Ref: SSD-73228210 (MOD 5)
Date: 7 April 2026

Re: SSD-73228510 (MOD5)
Property: 153 Parramatta Road, 53-75 Queens Road, Five Dock

Modification 5 seeks to allow signalisation of the Parramatta Road/William Street intersection (in-principle support from TfNSW), a new roundabout at the William Street/Spencer Street intersection, upgrades to the William Street/Queens Road intersection, additional traffic lane on the northbound side of William Street between Spencer Street and Queens Road, rearrangement of parking throughout the 4 basement levels for a total increase of 92 parking spaces.

Queens Road/William Street intersection

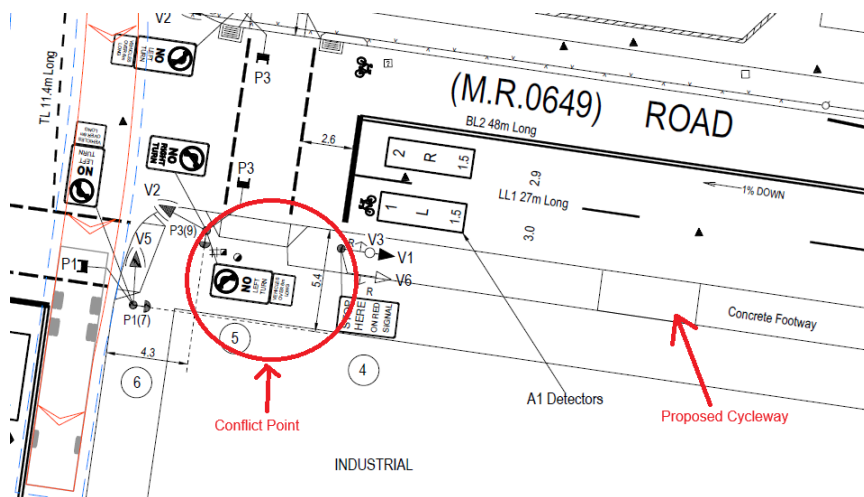
- The applicant should review the accessibility to the proposed bicycle parking spaces to ensure they comply with the access path requirements as specified by AS/NZS2890.3 Figure 2.4. An example of non compliance is shown below taken from Basement level 4 in the north eastern corner of the carpark where the encroachment from the storage cages has left only an approx. 900mm gap to pass through.

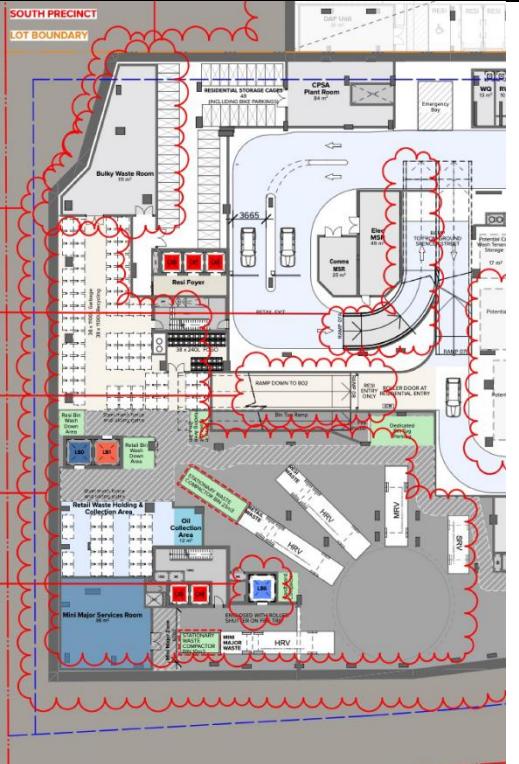
5	Basement 1	<p>Loading dock now located on B1</p> <p>Bulk waste room is located at the loading dock and 111m² space provided – the OWMP has a different space to the architectural plans – Council accepts the space provided on the</p>	Architectural drawings – Basement 01

<p>Architectural plans of 111m²</p> <p>Bin tug parking – this area needs to be secure and enclosed</p>	
6	Level 1	<p>Loading dock on level 1</p> <ul style="list-style-type: none"> Concerns around the size of the residential bin holding bay. There is an assumption applied that waste and recycling is collected on different days this is incorrect. The holding bay needs to be large enough to accommodate for all bins required for service on collection day. The previous space provided was 332m² the current MOD proposal has provided 109m² – less than half the previous space. The room size for the Bulk Waste Room must be provided – it is currently too small to see on the drawings. What is the residential FOGO bin zone – is this another holding bay for bins for service day or an actual FOGO bin room? If actual FOGO bin room, this room must 	<p>Architectural drawings – Level 01</p>
